**BEFORE
THE OHIO POWER SITING BOARD**

In the Matter of the Application of)
American Transmission Systems, Inc.)
and the Cleveland Electric Illuminating)
Co. for a Certificate of Environmental)
Compatibility and Public Need for the)
Geauga County 138 kV Transmission)
Line Supply Project)

Case No. 07-171-EL-BTX

**Applicants' Responses to
Staff's First Set of Interrogatories Directed to
Applicants and Request for Production of Documents**

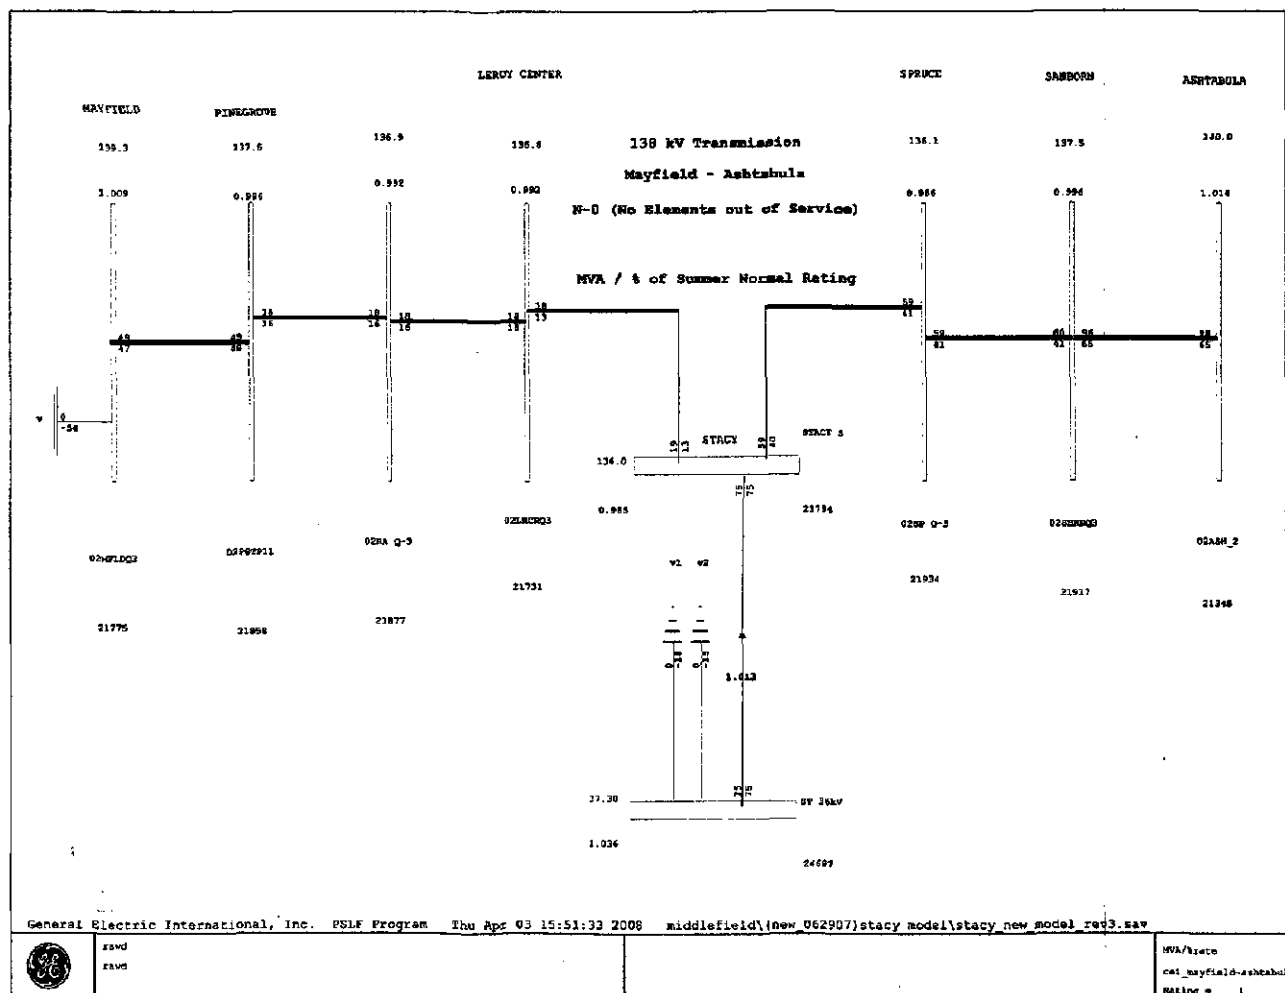
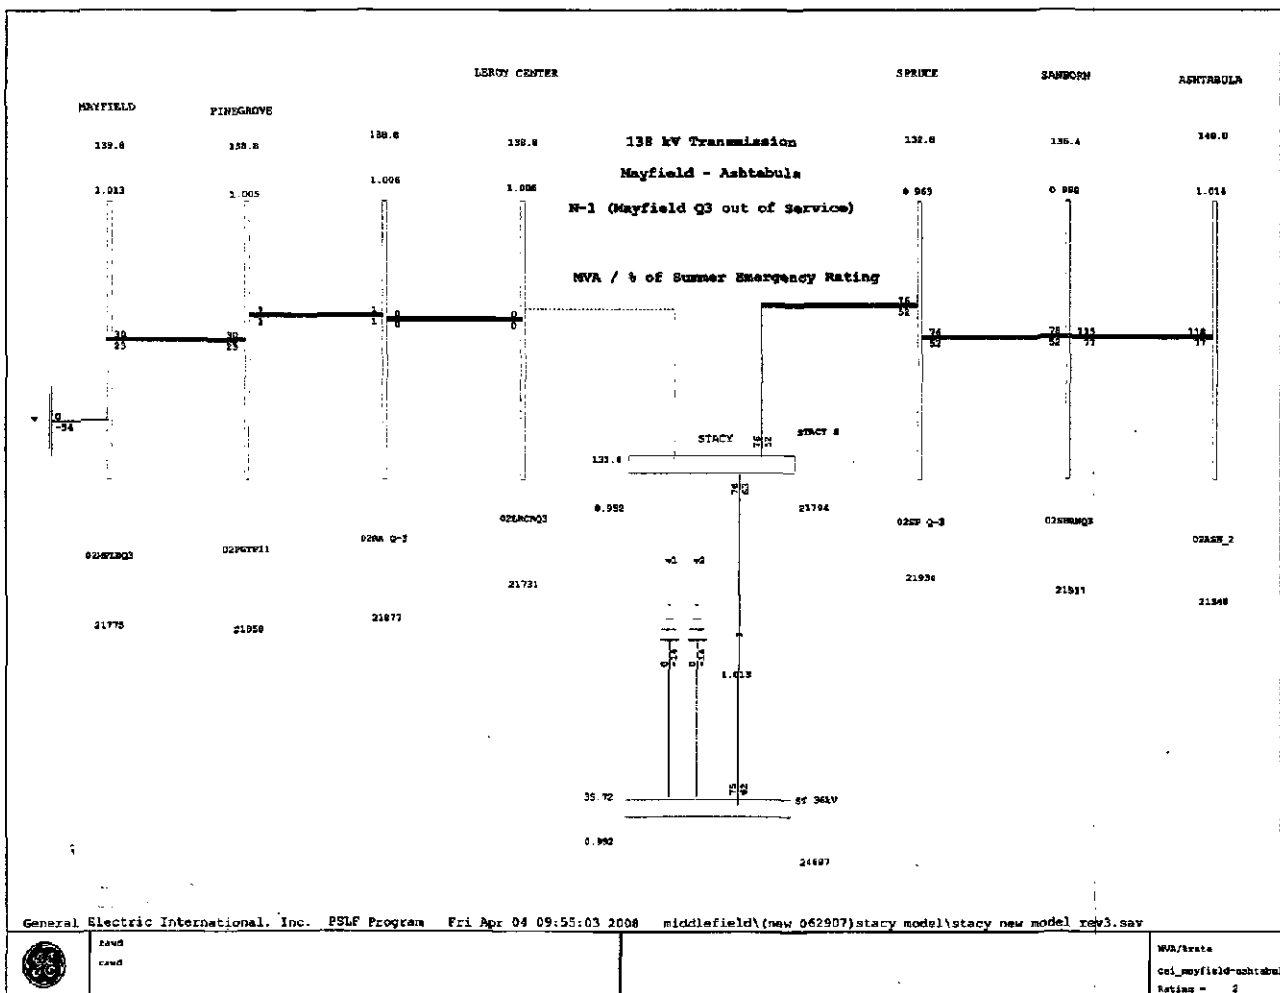
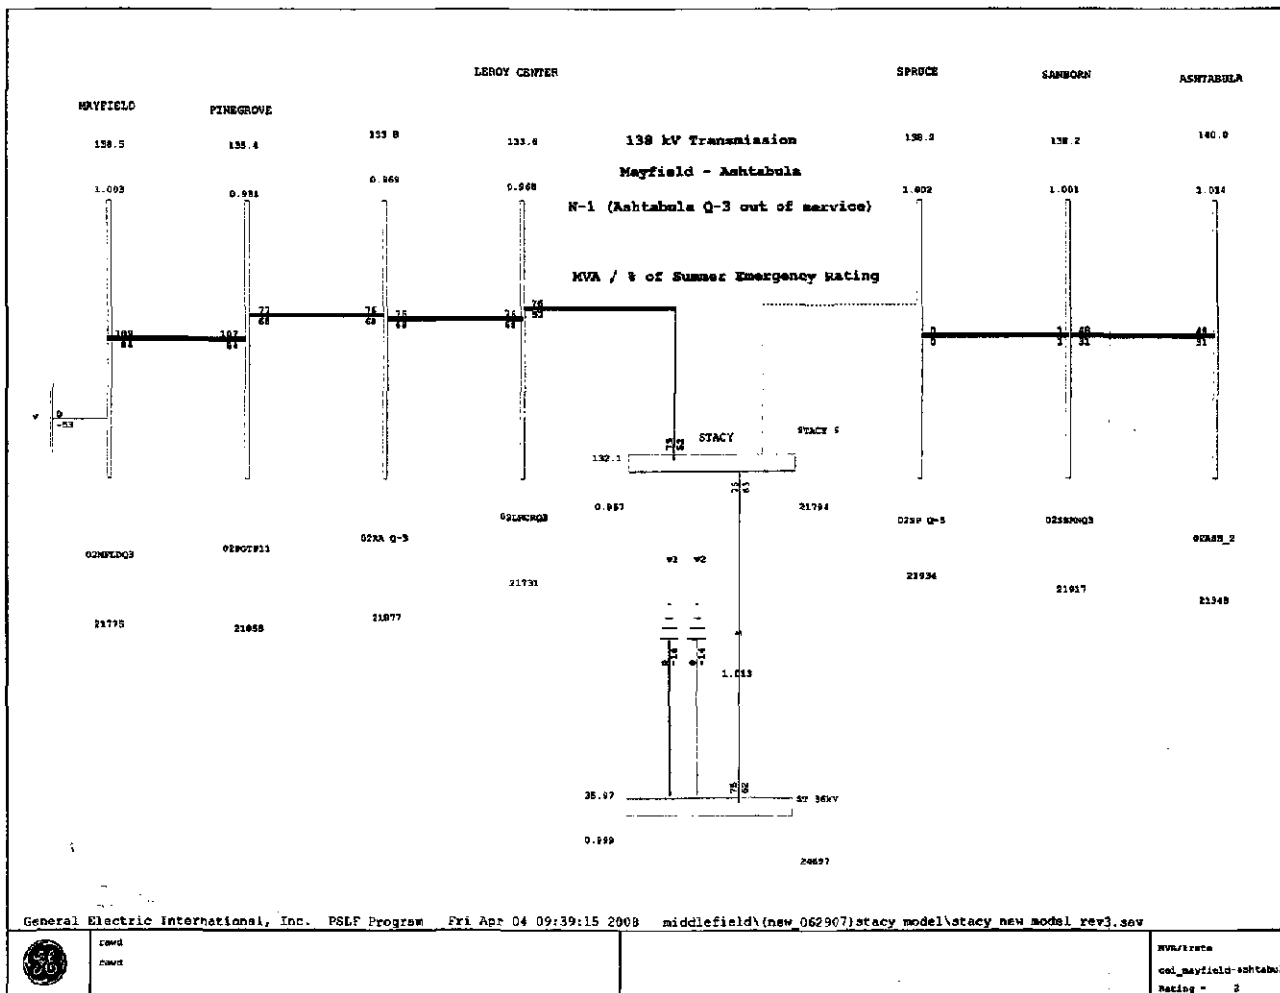
4. Provide the transmission system impact study or data for this project which shows that the transmission system will be able to supply the power requirements of the new Stacy substation along with any transmission up-grades or modifications necessary as a result of interconnecting the new Stacy substation.

On page 02-13, in the "Need" section of the application, there is an explanation of the impact of the proposed facility on the 138kV transmission system.

Additionally, FE is submitting PSLF drawings (one-line diagrams) that show the power flows under normal (N-0) and single contingency (N-1) conditions. Two drawings for the (N-1) conditions show Stacy being supplied solely from the Ashtabula side, and another shows Stacy being supplied solely from the Mayfield side. The quantities shown on these three drawings are MVA (top) and percent of rated (bottom). On the (N-0) drawing, the percent (bottom) ratings are shown as a percent of the Summer Normal rating. In the case of the two (N-1) drawings, the percent ratings are shown as a percent of Summer Long Term Emergency Rating. All of the component loadings shown on these drawings are consistent with FirstEnergy's Transmission Planning Criteria. At this time, there are no immediate plans to upgrade the local transmission system as a result of interconnecting the new Stacy substation.

ENGINEERING		DATE	9-6" 138Kv CONDUITS CONFIGURATION					
DR	J.GOLIAS	1/12/07						
CHKD								
APPD	J.GOLIAS	1/12/07	The Illuminating Company		DWG. NO.	EX-1	SHEET -	REV. -
SCALE		NONE	BRECKSVILLE, OHIO

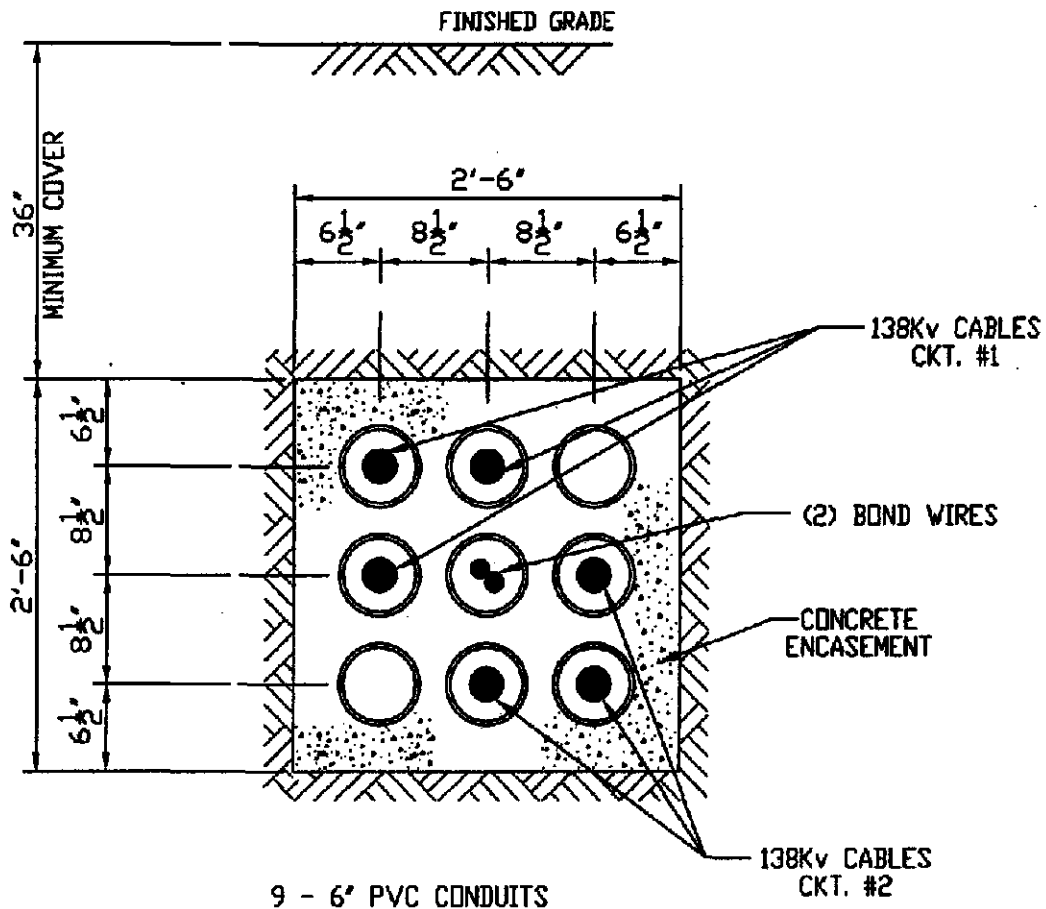
18. Regarding the Alternate Route along Clay Street, state whether the Applicant considered any of the following construction options: placing the entire facility underground, installing parts of the facility underground to alleviate concentrations of social impacts, routing behind residential properties to minimize impacts and frequent alignment adjustments from one side of the road to the other to reduce impacts. If so, provide a detailed explanation highlighting the rationale for rejection of these options.

Installing the proposed transmission line underground was not considered as a construction option for the Geauga County 138 kV Transmission Line project although the features of installing the transmission line underground were identified and reviewed. The general configuration of the conceptual underground design of the transmission line and the configuration of the conductor are provided in attached Exhibits 1 and 2, and would utilize 1500 Kcmil conductor. An underground installation of the transmission line would involve open cut construction techniques to install an approximately 30-inch square concrete duct bank, associated concrete vaults with nine six-inch PVC conduits, that would contain the conductors and bond wires. This option was rejected for several reasons including: The open cut installation potentially has greater impacts to streams, wetlands and agricultural fields than aerial crossings. Because the transmission line is located underground, outages to the transmission line may be more difficult to identify and repair, thus customer outages may be significantly longer. The conceptual cost for installing the transmission line underground, including material, labor and overheads for the cable and conduit, but not including any land purchases, right-of-way or permitting costs, is approximately \$4,000,000 per mile.
